REGIONAL REVIEW NOTIFICATION

Name of Proposal: The Avenue Ridgewalk
Review Type: Development of Regional Impact

Preliminary Report:	March 20, 2008	DEVELOPMENT OF REGIONAL IMPACT REVIEW REPORT	Project:	The Avenue Ridgewalk #1594
Final Report Due:	April 19, 2008		Comments Due By:	April 3, 2008

OVERALL SITE PLAN

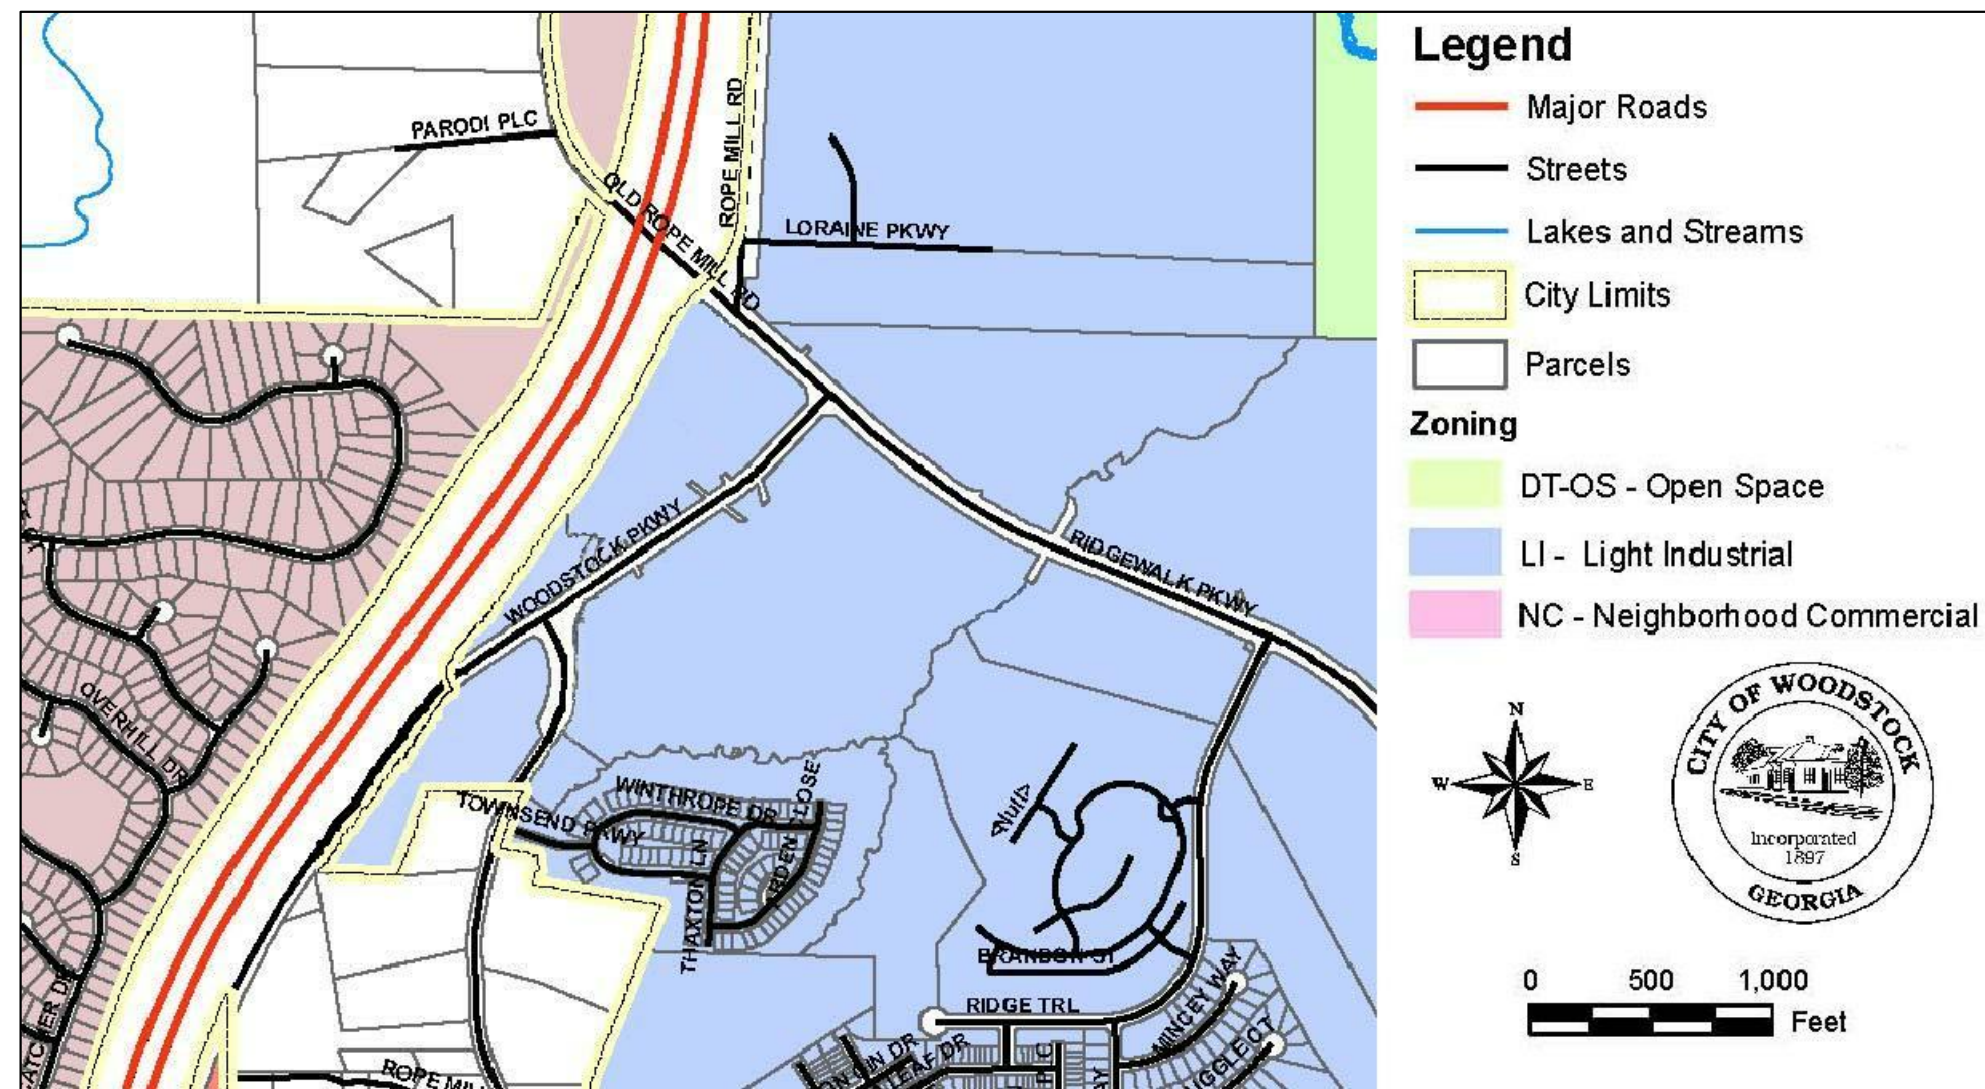
Information submitted for the review states that the proposed development is to be designed to be highly pedestrian friendly with wide sidewalks and aesthetic plantings and features throughout the development. However, currently there are no bus stops in the vicinity of the project and no sidewalks along any roadway to the proposed development. There are transportation projects proposed and being implemented that will include sidewalks; such as the new interchange ramps at I-575. ARC strongly recommends coordination with the City and GDOT to ensure that a unified sidewalk system is implemented along the corridor. ARC also recommends alternative routes be considered for pedestrian and bicyclists to access the proposed development. Furthermore, buildings should be brought to the street with minimum setbacks so that the parking can be screened.

An unnamed tributary to the Little River forms the southern and southeastern boundaries of the project property. The site plan shows the 25-foot State sediment and erosion buffer along the stream, but no City of Woodstock stream buffer is identified. The proposed grading for the project as shown on the plans comes nearly to the edge of the indicated 25-foot buffer. Any intrusion into City of Woodstock buffers may require a variance from the City. Any intrusion into the State sediment and erosion buffer will also require a variance.

- Coordinate with the Cherokee Area Transportation System (CATS) to assess whether fixed route bus service to the proposed development would be warranted. If so, provide appropriate accommodations for such service.
- Side walks along the public roads should incorporate a buffer zone between the curb and the pedestrian right of way. ARC recommends a three foot vegetative strip.
- Section 1.2 'Bicycle and Pedestrian Facilities' in the travel analysis does not reference any sidewalks along Rope Mill Road. The development should provide appropriate pedestrian facilities along all public roads adjacent to the proposed site.
- Currently there is no direct connection from Rope Mill Road to the proposed development. Such a connection would help reduce the need for northbound traffic using Rope Mill Road to turn onto Woodstock Parkway to access the site.
